SERVICE BULLETIN

TR-9130 Low Drive Level

7-05-83

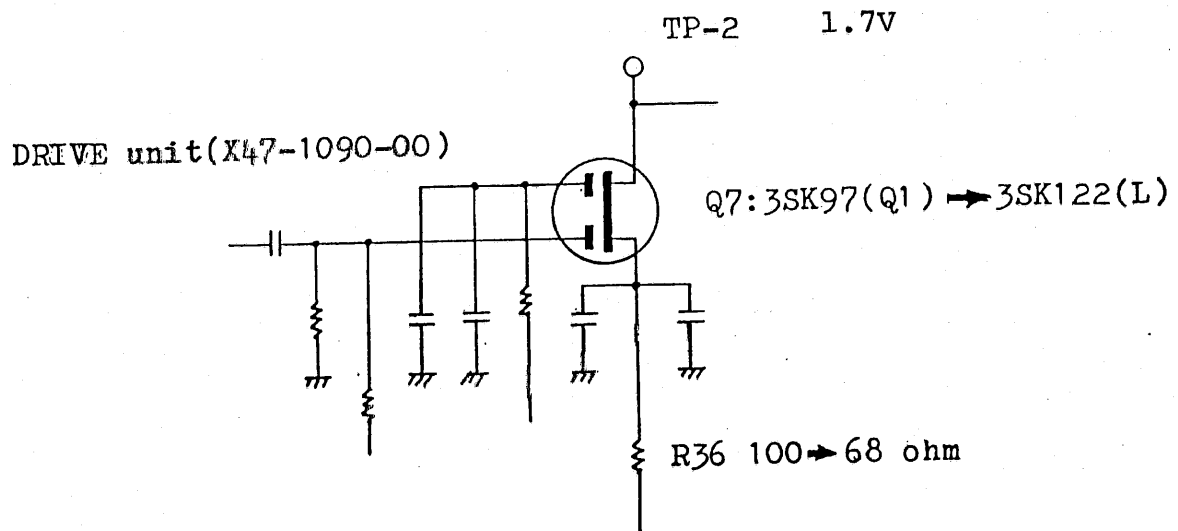
For reported cases of low transmit power output check the level of the TX driver transistor Q7 of the DRIVE unit (X47-1090-00). If the TX drive level is low make the following changes.

Old Part

Q7: 3SK97 (Q1)
R36: 100 Ω

New Part

3SK122 (L)
68 Ω (RD14BB2E680J)
